TITLE: PELI 1120 CASE DESIGN REFINEMENTS

PRODUCTS AFFECTED: PELI 1120 CASE

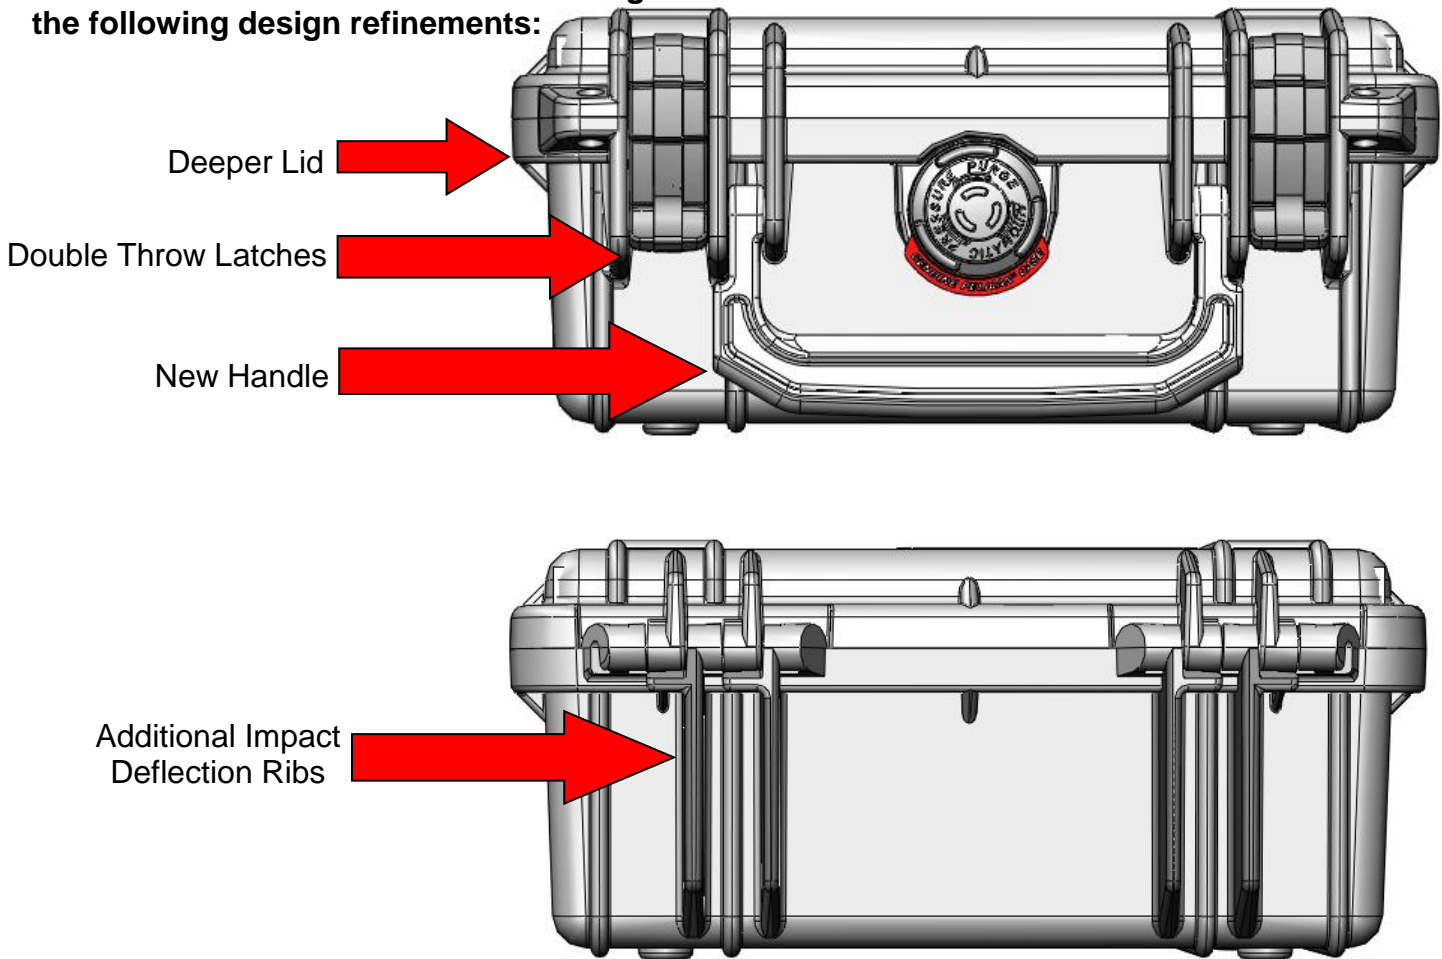
DETAILS: The Peli 1120 Case has undergone the following design refinements:

| Prior Internal Dimensions |       |        | New Internal Dimensions |       |        |
| Length                    | Width | Height | Length                  | Width | Height |
| 7.25"                     | 4.75" | 3.06"  | 7.46"                   | 4.96" | 3.33"  |
| Prior External Dimensions |       |        | New External Dimensions |       |        |
| Length                    | Width | Height | Length                  | Width | Height |
| 8.12"                     | 6.56" | 3.56"  | 8.41"                   | 6.76" | 3.87"  |
